US SAFETY DIRECTIVE NUMBER 127
including

ISSUE 2

MODIFICATION M228

TITLE	CKT exhaust
CLASSIFICATION	The UK CAA have classified this as Mandatory.
COMPLIANCE	All aircraft, Inspection before further flight. At or before the next annual renewal, fit modification M228 or modified exhaust (exhaust serial number 10940809 onwards)
APPLICABILITY	All Quik, GT450 & QuikR fitted with CKT stainless steel twin exhausts. The CKT exhaust serial number is stamped on one end cover plate.

Fig 1. Crack location all round weld outer edge

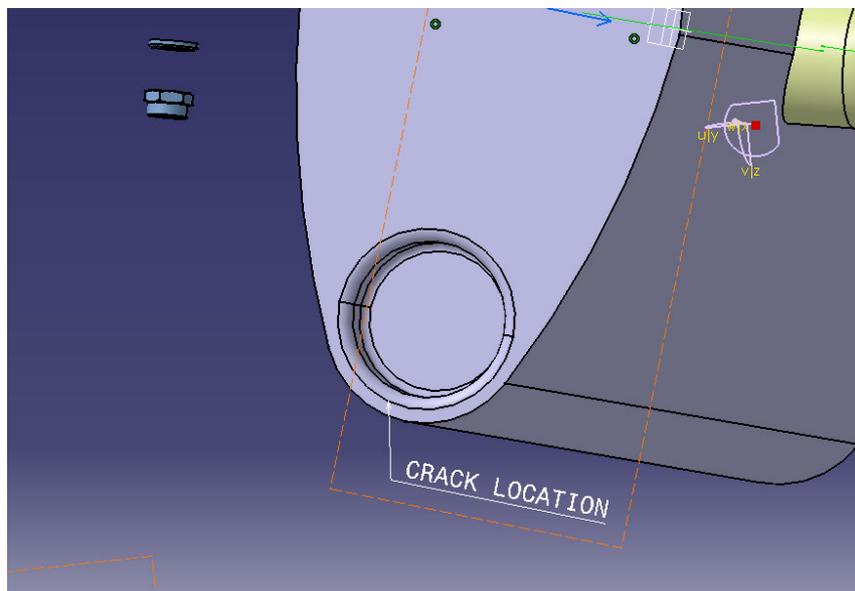
The CKT exhaust silencer has separate front and rear perforated baffle tubes which are welded to the front and rear end cap flanges and plugged with a cap. A fatigue failure of a pair of exhausts serial no. 7811107 has occurred at 125 hours, around the flange edge on the rear end cap, at the weld edge (see fig 1). The baffle tube came free and was ejected from the silencer and hit the propeller. Fortunately this happened at low power on approach, propeller damage was localised and the baffle tube missed the sail; under high power the consequences could be very serious.

Before further flight, using good light and a magnifying glass, closely inspect the area around all 4 silencer end caps for cracks, particularly on the weld edges (see fig 1). If cracks are noted, contact P&M Aviation, if possible by email attaching pictures of the damage, hours run, aircraft and exhaust serial numbers. The aircraft must not be flown with cracks in this area.

Fig 2. Movement of inner baffle plate.

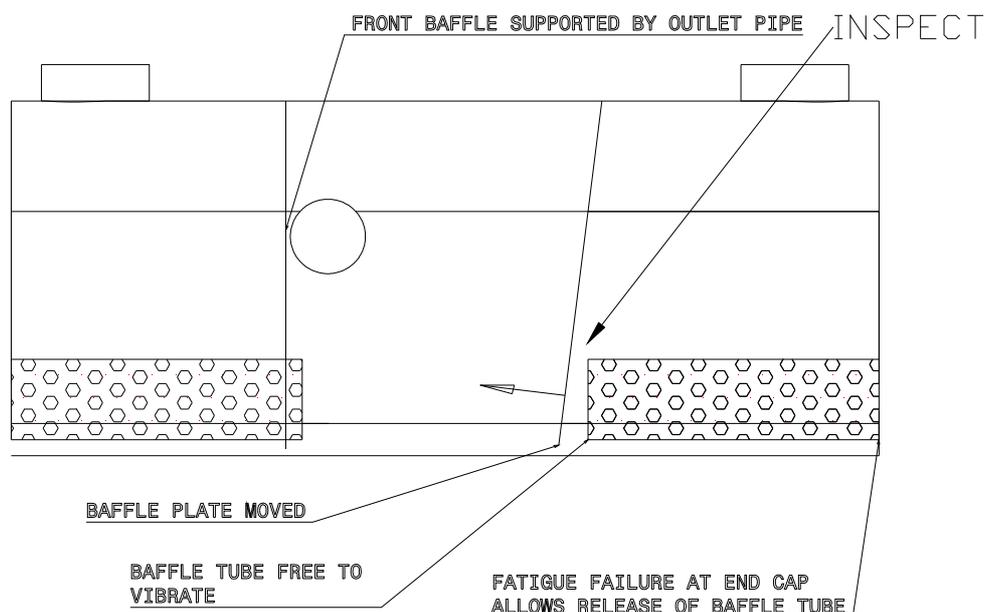
See fig. 2. Through the exhaust header pipe holes, using a torch and mirror, inspect the welded connection between the internal baffle plate and the end of the perforated baffle tube. Try pushing the bottom of the internal baffle plate inwards. If the baffle plate has moved inwards towards the centre of the exhaust and the baffle tube has disengaged from the baffle plate, **the exhaust must be replaced**. Disengagement is more likely on the rear internal baffle, as the front internal baffle is supported by the outlet pipe.

Fig 3 Exhaust Keeper modification M228

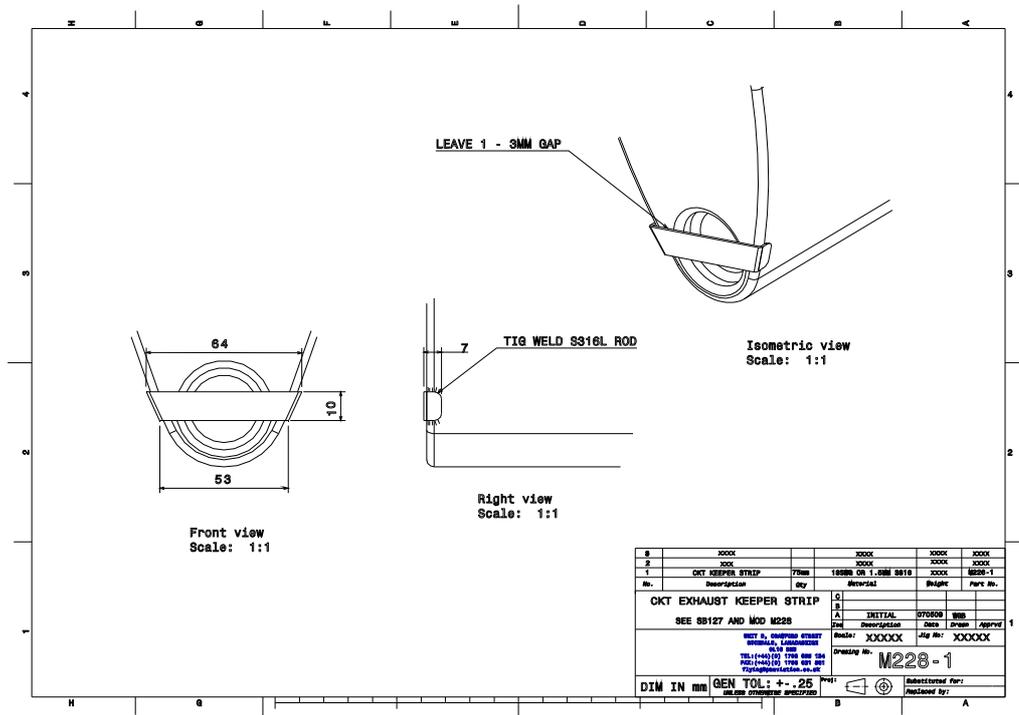
If the inner ends of the baffle tubes and internal baffles are secure, modification M228 can be carried out (see fig. 3). It provides a backup retainer if the baffle should become loose. Thoroughly clean the area. Do not use any dissimilar wire brush metals and do not mark with graphite or carbon pencils. Weld repair any cracks found using a stainless steel 316L welding rod and TIG process. Fit a 10mm wide x 18swg (1.22mm) or 1.5mm S316 strip with 7mm bent edges as shown, weld to the silencer ONLY at the corners, over the existing corner weld. The repair/modification must be carried out by a welder qualified for thin (0.9mm) stainless steel. FAA publication AC43-13-1B is a useful guide to procedures.

The problem has been solved by welding on back-keeper plates (modification M228), or by fitting new modified exhausts which have smooth end caps with no baffle tube features.
